Posted
Amdt. 67
to NPF-5

EDWIN I. HATCH NUCLEAR PLANT, UNIT NO. 2

AMENDMENT TO FACILITY OPERATING LICENSE

Amendment No. 67
License No. NPF-5

BASES FIGURE B 3/4 3-1
REACTOR VESSEL WATER LEVELS

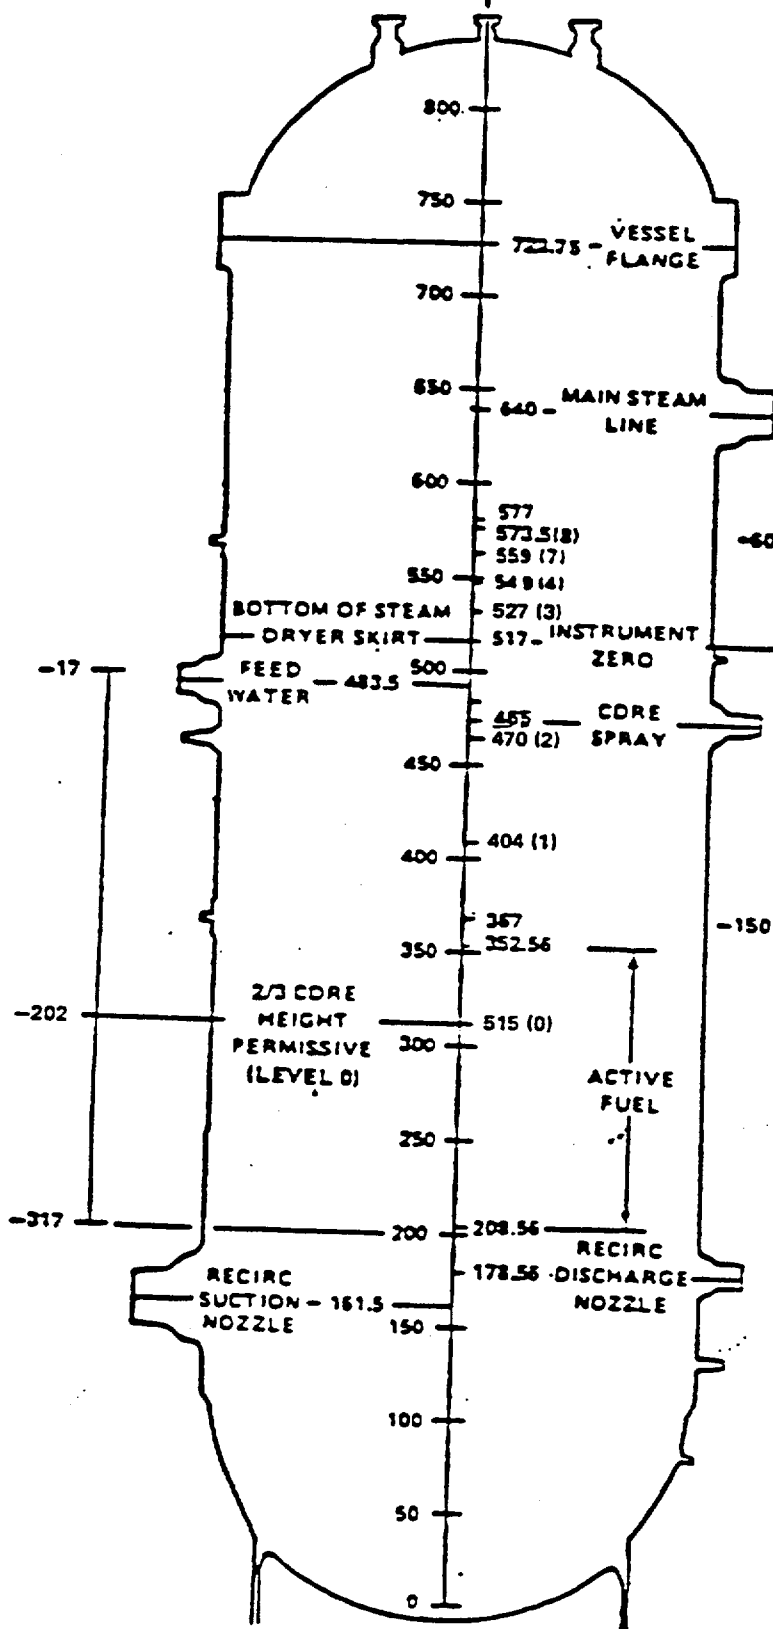
The original design of the ATTS used Barton Models 763 and 764 transmitters. GPC has decided to replace the Barton transmitters with Rosemount Models 1153 and 1154 transmitters, because they offer increased operational and maintenance flexibility. Because the accuracy characteristics of those transmitters differ, the Technical Specifications allowable values need to be revised in order to accommodate the new transmitter types. In particular, the following changes were proposed in change 1:

<u>Trip Function</u>	<u>Present Allowable Value</u>	<u>Proposed Allowable Value</u>
Reactor Vessel Water Level 1	-121.5 inches	-113 inches
Reactor Vessel Water Level 2	-55 inches	-47 inches
Reactor Vessel Water Level 3	8.5 inches	10 inches
Reactor Shroud Water Level 0	-207 inches	-202 inches
Reactor Vessel Steam Dome Pressure Low	325 psig	335 psig
HPCI Steam Line High Flow	307%	303%
RCIC Steam Line High Flow	307%	312%

NO.	(INCHES)	READING	INSTRUMENT
(8)	573.5	+56.5	BARTON
(7)	559	+42	GE/MAC
(4)	549	+32	GE/MAC
(3)	527	+10	BARTON/ROSEMOUNT
(2)	470	-47	BARTON/ROSEMOUNT
(1)	404	-113	BARTON/ROSEMOUNT
(0)	315	-202	BARTON/ROSEMOUNT
